C-108 (Class II water disposal well)
Application for Authorization to Inject
Caleb Mesa SWD #1
Sandoval Co., NM

APPLICATION FOR AUTHORIZATION TO INJECT

Subject: SWD Application from Synergy Operating LLC: Caleb Mesa SWD #1 in the Entrada from 6000 to 6200 feet

WELLBORE SCHEMATIC

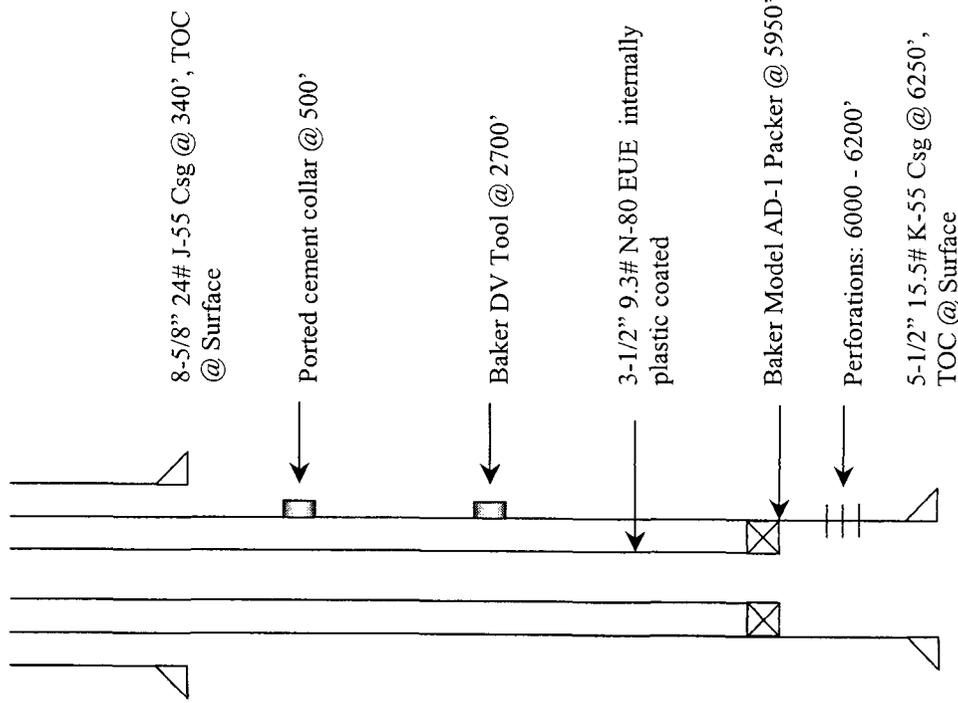
4) You are installing 5-1/2 inch casing then running 3-1/2 inch plastic coated tubing? Why not run bigger casing?

- 3) A swabbed water sample will not be a problem. Should we send the completed analysis to your attention, or to someone else?
- 4) The 5-1/2" casing size is a function of the cost to drill the well. The larger hole size, equates to increased drilling costs, cementing costs and casing costs. The internal casing diameter of 5-1/2" 15.5# casing is still sufficient to allow 3-1/2" PCID tubing, which would be the maximum size of a tubing string that we would run in the well. We decided to permit the larger tubing size in case it was needed to allow the injection of the permitted volume of water, under the maximum allowable pressure.
